**ASHLAND PLANNING COMMISSION  
REGULAR MEETING  
DECEMBER 13, 2011  
AGENDA**

**A. PLANNING ACTION: #2011-01576**

**SUBJECT PROPERTY: 1554 Webster Street** (*on the Southern Oregon University campus*)

**ASHLAND PLANNING DIVISION  
STAFF REPORT  
December 13<sup>th</sup>, 2011**

## S-3. STAFF SUGGESTION

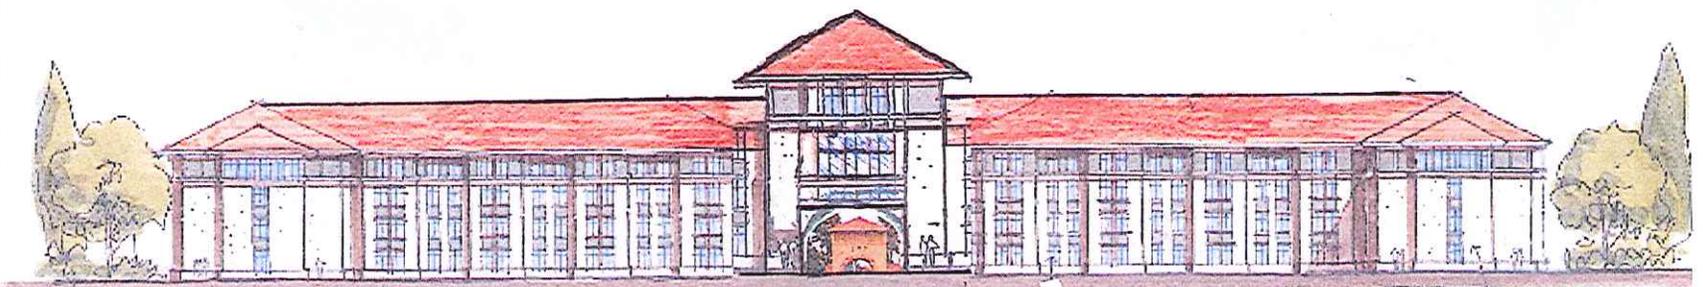
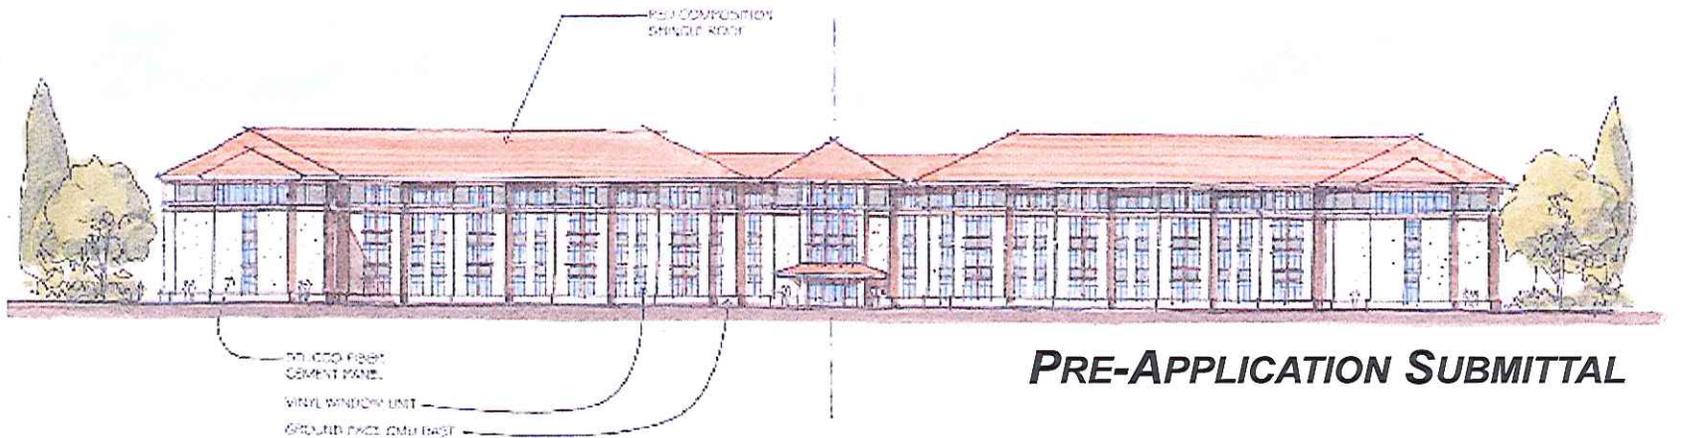
**STAFF SUGGESTION - STRENGTHEN ENTRY, BETTER RELATE TO STREET & BREAK-UP LENGTH**
